08 Soft Landscape Strategy: Amendment Response

Pears Building

Fig 19 Proposed Amendment - Soft Landscape Strategy Refer to note 8.1

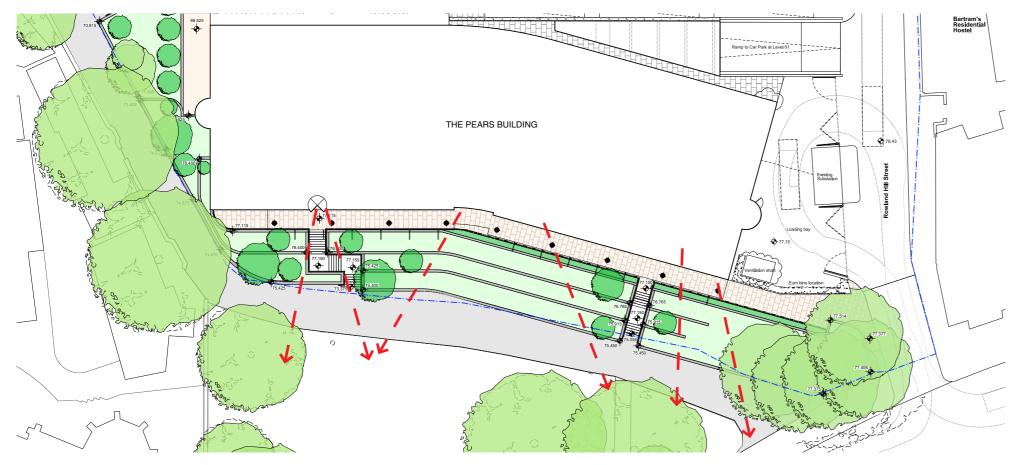
The consented scheme strategy for existing and proposed trees remains unchanged. Refer to Section 10 for the outline of the effect of the proposed landscape amendment on the existing trees.

As seen on the diagram above, the proposed amendment does not change the consented scheme concept to provide views out towards Rosslyn Hill, Hampstead Green and the new planting from the interior

The UCL Garden and the Heath Strange Garden spaces to the east of the building are not part of this amendment.

The detailed proposals for planting species to be submitted at a later date. The consente scheme concept to be followed, unless dimensional restrictions of available green space require changes to proposed species.
